AMENDMENT NO. 53 TO THE OFFICIAL PLAN

135, 139, 147, 153 and 161 Jackson Avenue and 136 Brentwood Avenue

To:	Brian Bateman, Senior Planner
From:	Juliane vonWesterholt and Trevor Hawkins, MHBC Planning
Date:	April 26 th , 2024
Our File:	22184 A
Subject:	135-161 Jackson Ave. and 136 Brentwood Ave. OPA and ZBA applications

**RE: 135-161 JACKSON AVENUE AND 136 BRENTWOOD AVENUE, KITCHENER
EMERGENCY ACCESS ON BRENTWOOD AVENUE**

Location of Brick Wall
MTE/ April 23, 2024

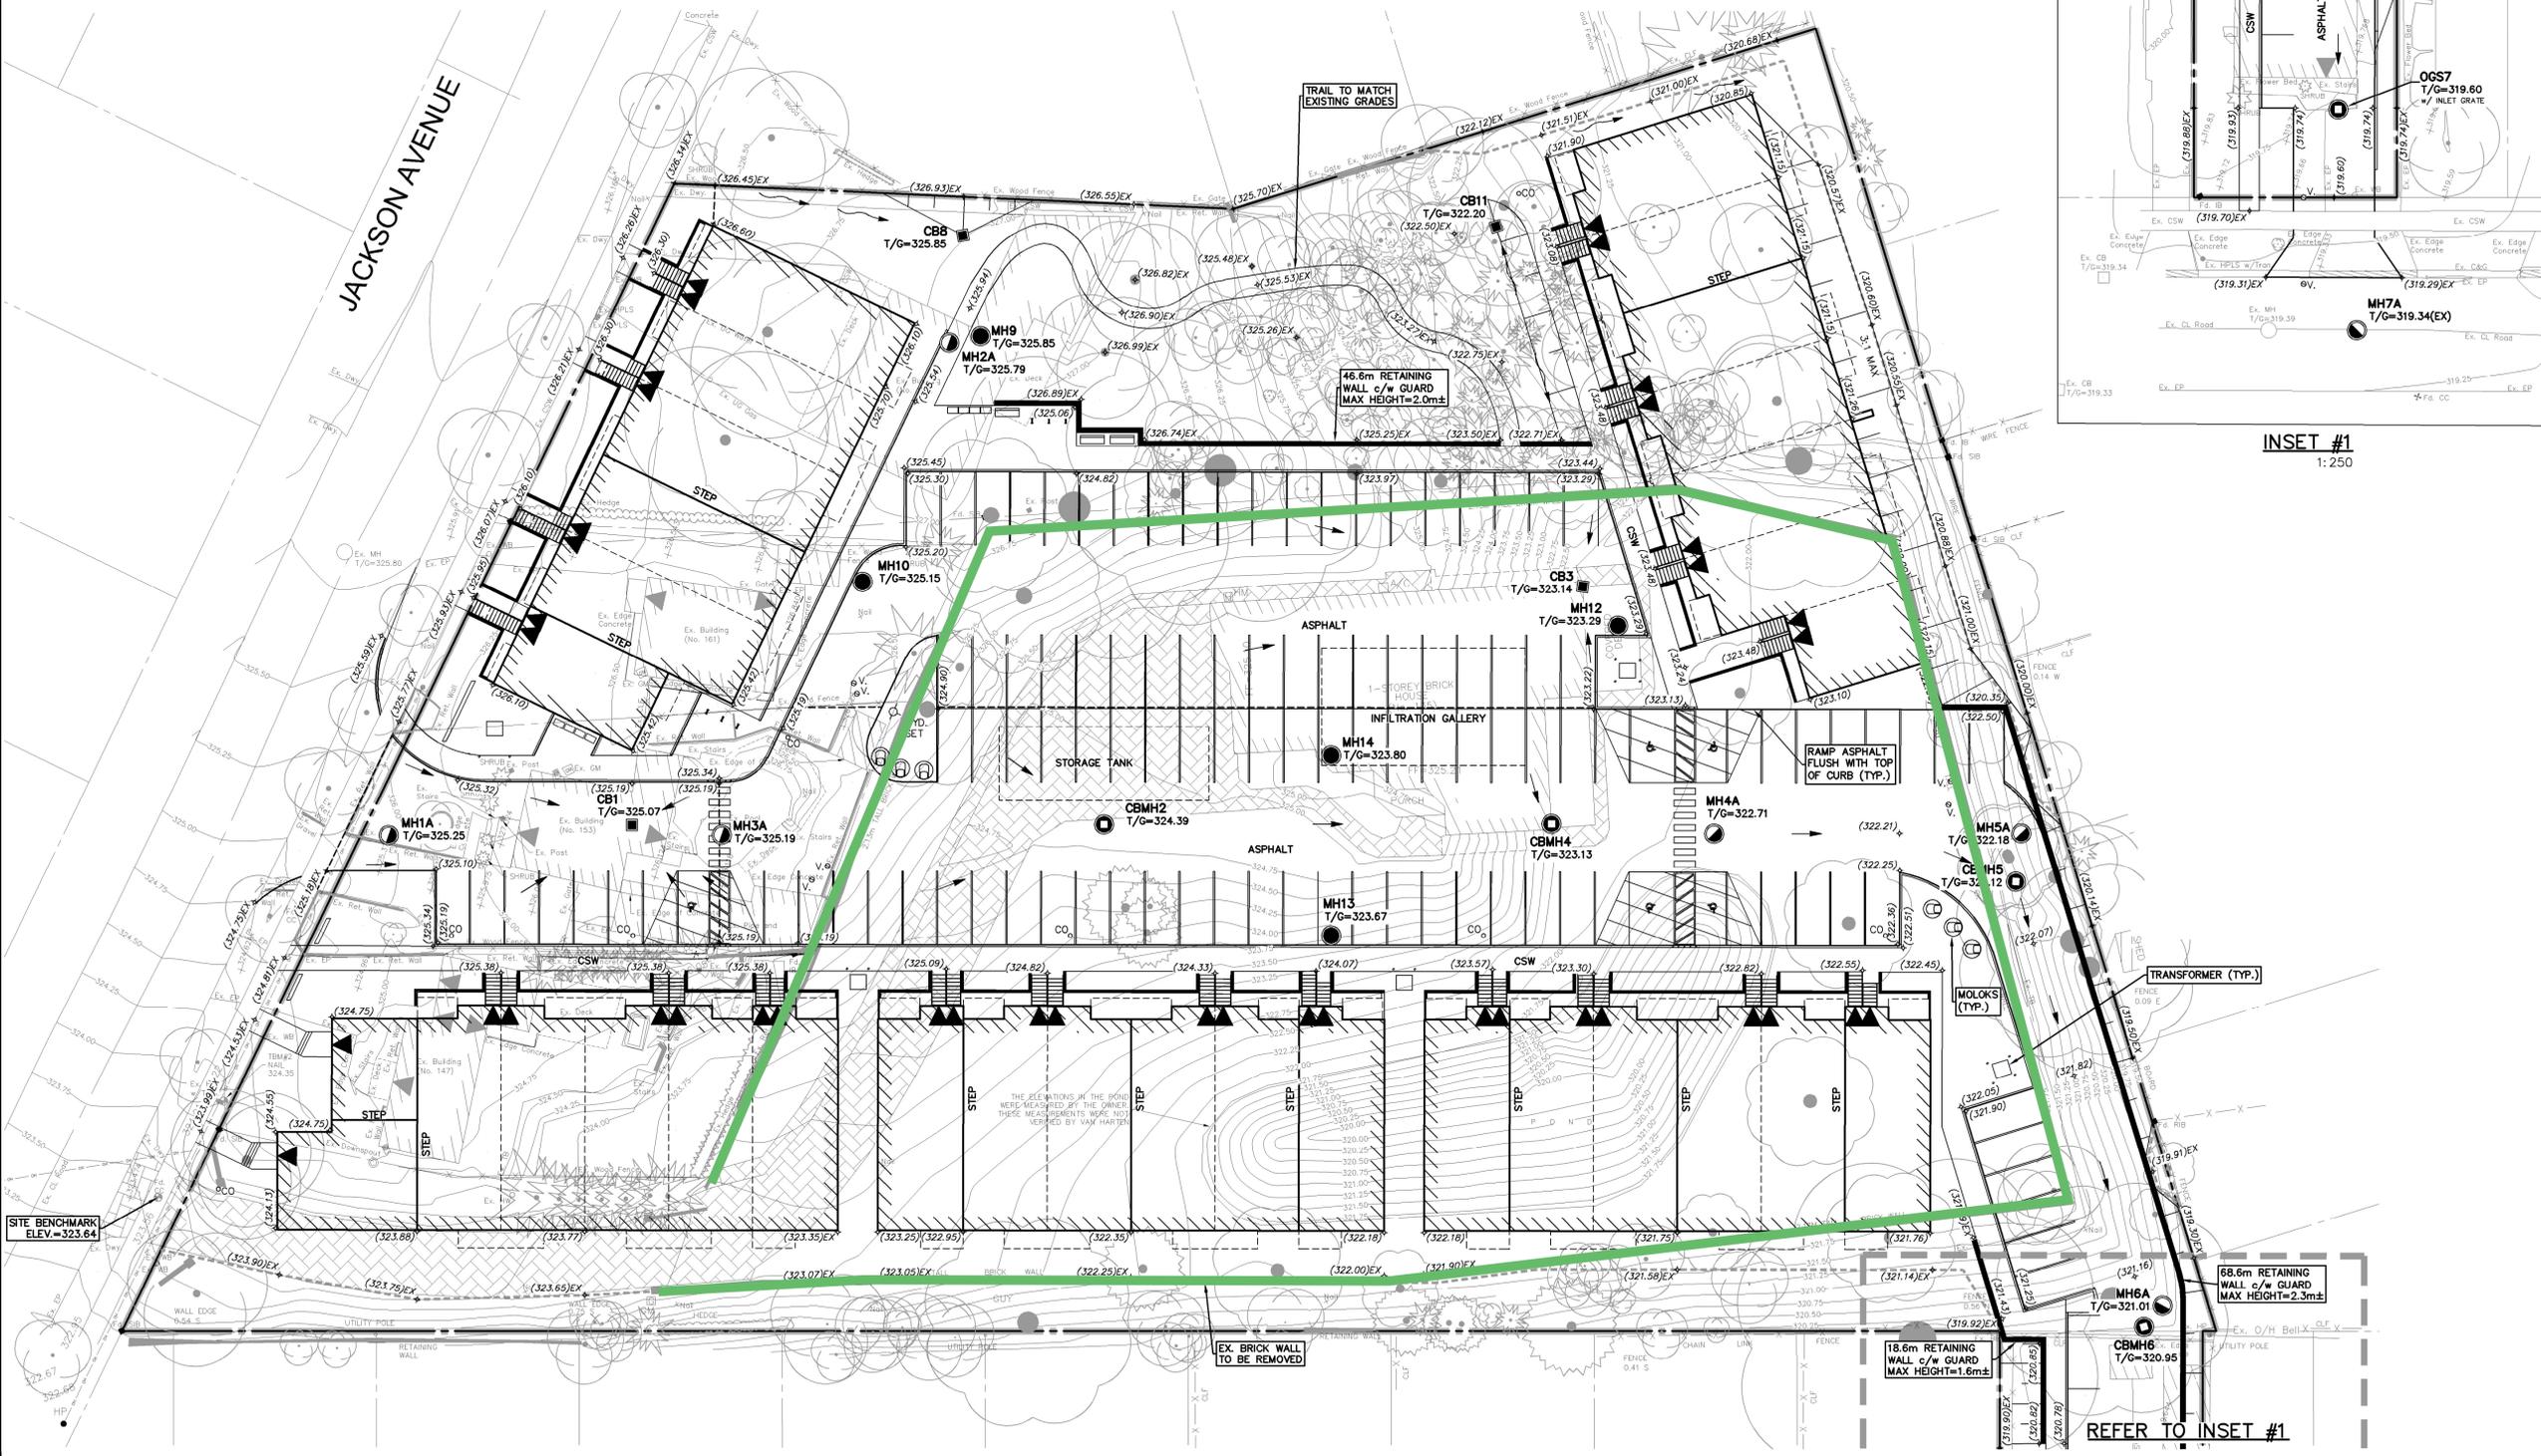
You will recall there is an existing wall associated with the existing detached dwelling. The wall does not coincide with any shared property line and is entirely within the limits of our client's property. At the Meeting, it was suggested that portions of the wall be retained where feasible.

The aforementioned brick wall is approximately 8 feet in height around portions of 135 Jackson Ave. The intent of that wall was to restrict views into the rear yard of the dwelling at 135 Jackson Ave. As noted above, the wall is not situated near any shared. A survey plan has been provided below as Figure 1 to demonstrate the exact location of the wall.

The wall must be removed in its entirety to facilitate the redevelopment of the subject lands. As you are aware, efforts have been made through the design to retain as many boundary trees as possible. If the wall were reconstructed along shared property lines, there would be impacts to these trees, which may require their removal. The owner's preference is to preserve the trees. Further to this, dismantling the wall and reconstructing it in parts would add significant cost to the development, which would increase the cost of the units. .

The City has a policy that requires a fence around a property where multiple residential uses are located adjacent to single detached low-rise residential uses. The owner is committed to providing a quality wooden, board on board style fence along the property line around the perimeter of the

Figure 1

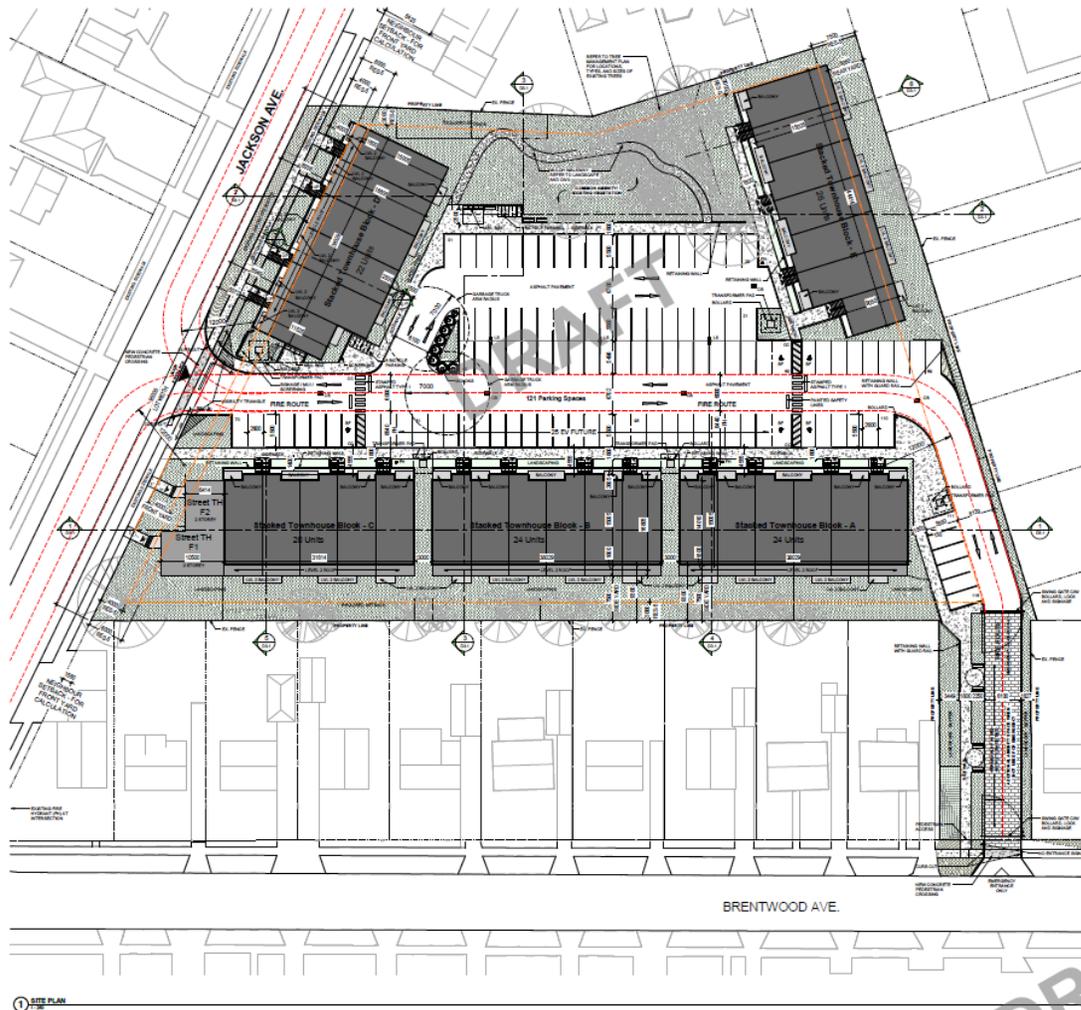
Council requested that consideration be given to closing the full access onto Brentwood to through traffic and instead, limit this access to emergency vehicles only. This alternative has been carefully evaluated by the project team.

The access can be converted to an emergency only access with permeable pavers rather than asphalt. A fence along the common property line with 132 and 140 Brentwood Ave. and a gate along the frontage to prevent through traffic from entering the subject property can also be provided. The area outside of the driveway can be landscaped and used a passive amenity space (See revised Site Plan Figure 3)

Access to the development was identified through two driveways, one each on Jackson Avenue and on Brentwood Avenue. Following public consultations including Council Meeting on Monday, April 22, and comments received, a new access arrangement is being proposed to provide a single full access on Jackson Avenue and emergency access only on Brentwood Avenue.

Figure 1 (attached) includes the revised Site Plan indicating the new access arrangement.

November 2023 TA Site Generated Traffic Volumes

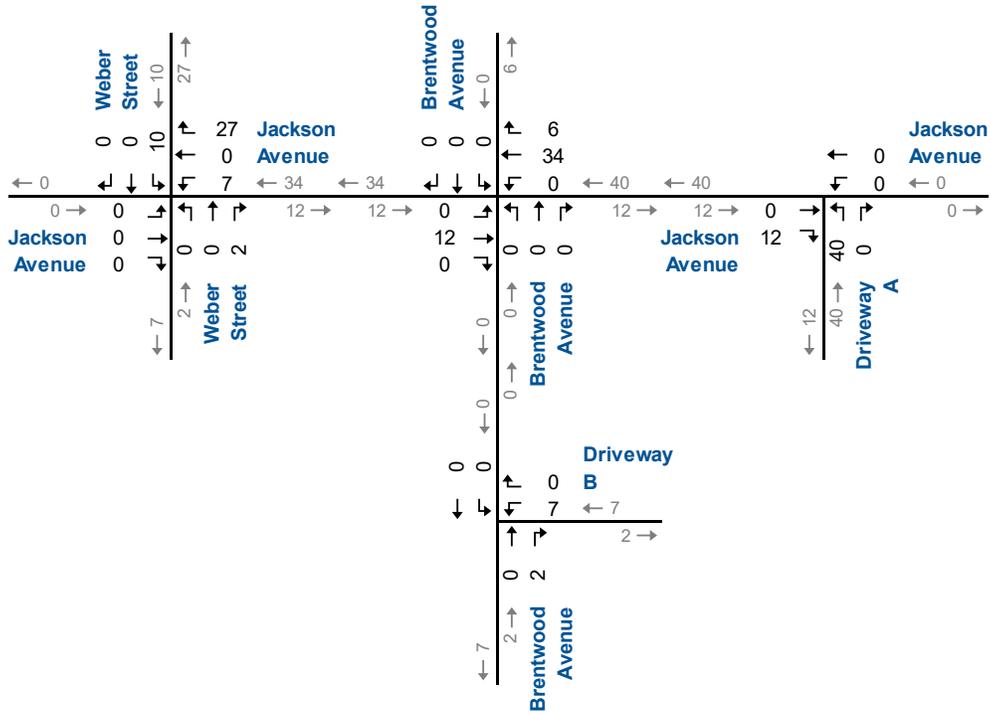
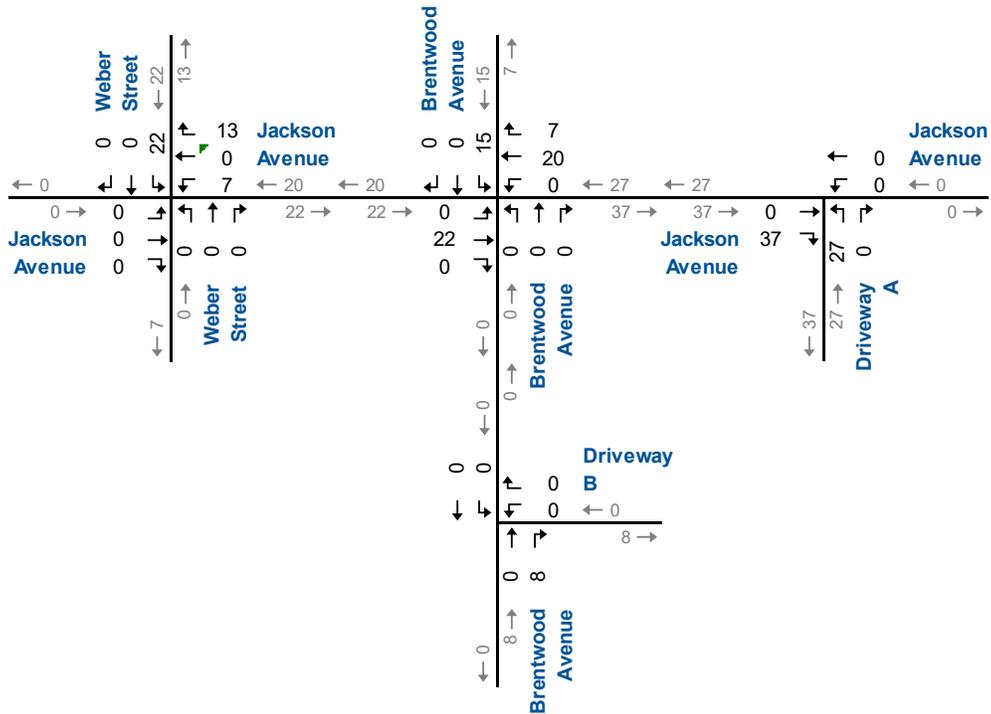
Figure 2 illustrates the site traffic volumes from the November 2023 TA (Figure 3.1 in the TA).

Emergency Access Site Generated Traffic Volumes

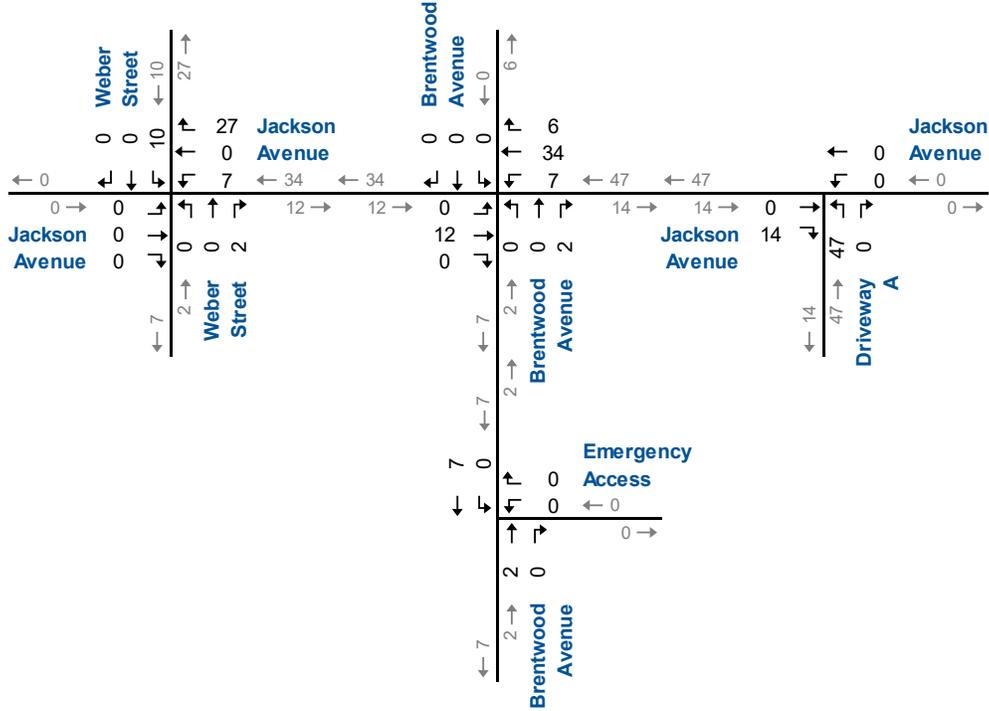
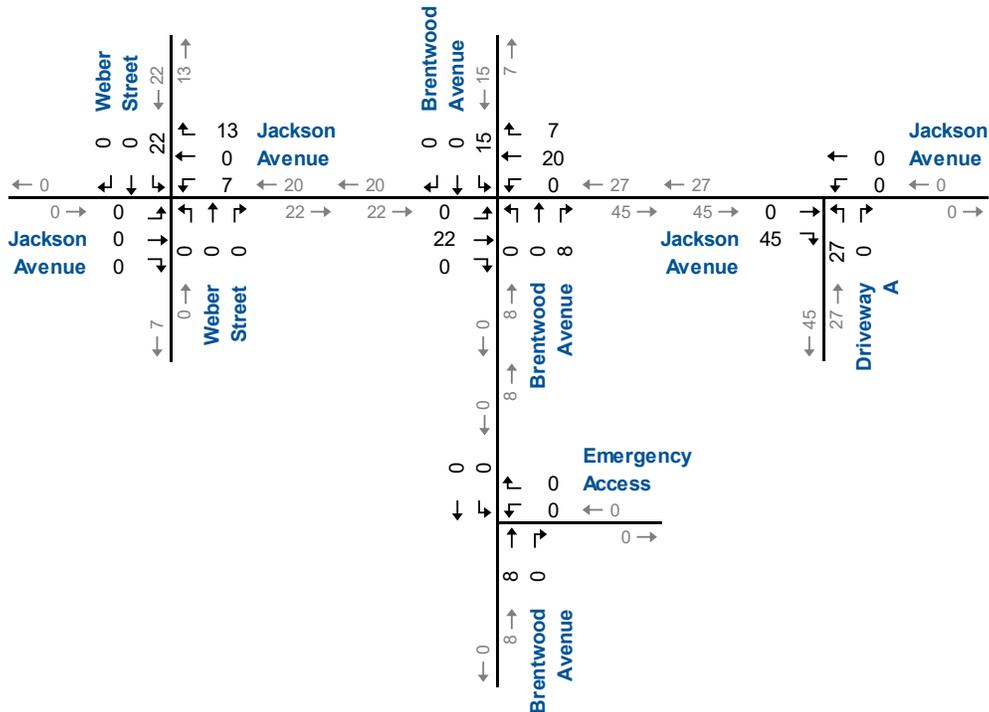
With the Brentwood Avenue access restricted to emergency use only, the driveway volumes at Jackson Avenue will increase from 12 inbound and 40 outbound trips to 14 inbound and 47 outbound trips during the AM peak hour; and from 37 inbound to 45 inbound trips during the PM peak hour.

Figure 3 illustrates the new traffic volumes at the Jackson Avenue driveway operating as a single full access to the subject development.

The above changes can be satisfactorily accommodated by the proposed single access on Jackson Avenue and there will be minimal changes to the distribution of development traffic on the adjacent road system.

Drawing Name:
**3D STREET ELEVATION
FROM BRENTWOOD**

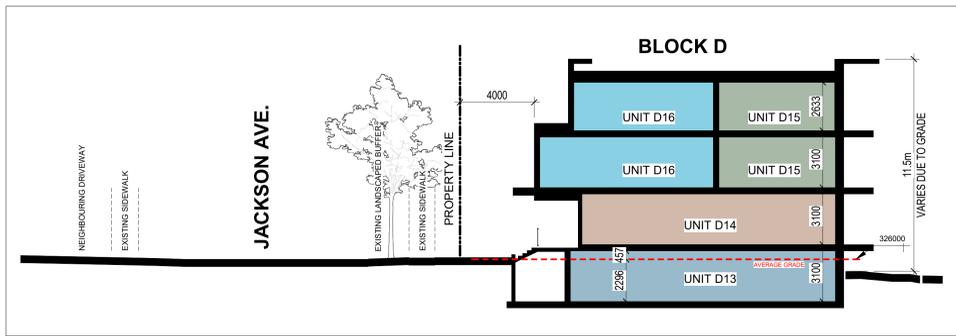
Although, in our opinion the proposed height of the buildings are appropriate in their context, we have discussed the potential to lower the height from 12.5 m to 11 m in response to comments received on the 22nd. This would necessitate lowering the internal floor to ceiling height within the units from 9 feet to 8 feet.

The project architect, SRM Architects, has explored a design that reduces the height by 20 cm for each floor. In addition, consideration was given to recessing the lower unit further into the ground. These two revisions result in an overall building height reduction from 12.5 m to 11.5 m.

A revised rendering showing the streetscape along Brentwood has been provided which demonstrates only a single storey above the Brentwood homes is visible from the street (see attached Figure 2)
